**BELLEFONTE COMBINED LICENSE APPLICATION – RESPONSE TO REQUEST
FOR ADDITIONAL INFORMATION – SEISMIC DESIGN PARAMETERS**

NRC RAI NUMBER: 03.07.01-03

**Revision to FSAR Section 2.4.4
(32 Pages including Cover Sheet)**

Comparison of BLN OBE Demand to Existing Dam Evaluations

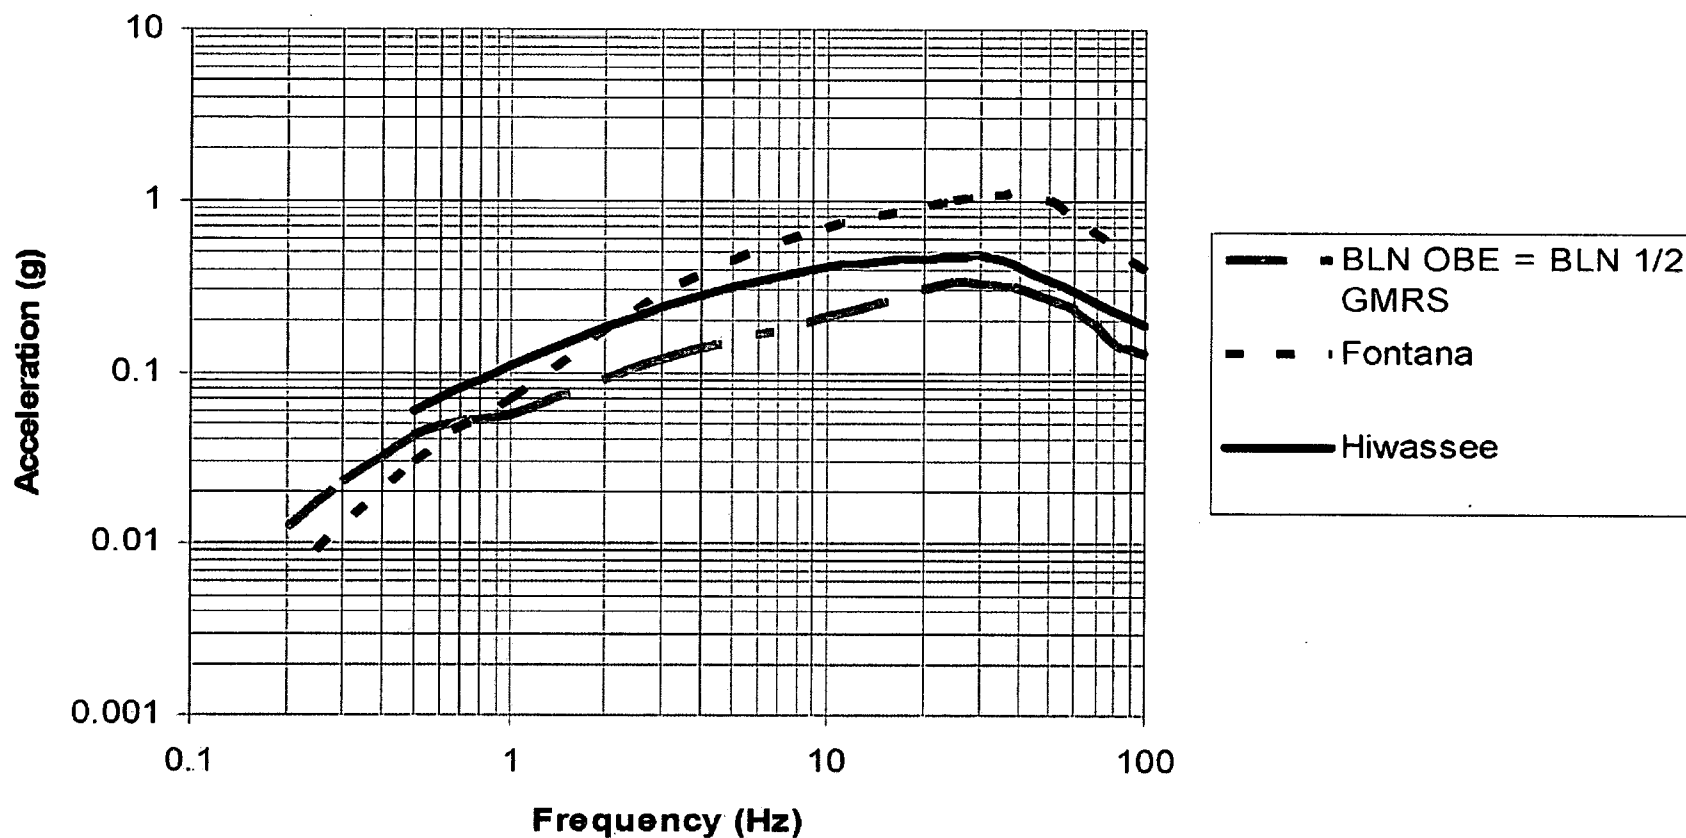
RAI: The staff requires clarification about the seismic classification of dams and the analysis methods and acceptance criteria that have been applied in the “evaluation of existing and new dams whose failure could affect the site interface flood level specified in DCD Subsection 2.4.1.2,.....” The staff requests the applicant to provide the following information for BLN COL 3.7-1:

- (a) Are there any Seismic Category I dams associated with the Bellefonte site? If so, describe the analysis methods and acceptance criteria that have been applied to confirm they do not collapse under the GMRS.
- (b) What organization has jurisdictional responsibility for the dams whose failure in an earthquake could affect the site flood level? Is there an established seismic design basis for these dams? If so, please describe it.
- (c) In estimating the maximum site flood level, including seismic effects on these dams, have all dams been assumed to fail under the effects of the site GMRS? If not, describe in detail the technical basis for making determinations of complete failure, partial failure, and no failure under the effects of the site GMRS.

A comparison of the BLN OBE^(b) to the response spectra used in the TVA DSP analyses for Fontana and Hiwassee is made in Figure 2.4.4-201. These analyses envelope the BLN OBE demand and therefore provide further evidence that the assumption of catastrophic failure of Fontana and instant disappearance of Hiwassee Dam is extremely conservative. In addition, these analyses give confidence of the ability of other similar TVA dams to withstand the high frequency demand of the BLN Ground Motion Response Spectra (GMRS). Apalachia, Fort Patrick Henry, Melton Hill, and Ocoee No. 3, which are concrete gravity dams,
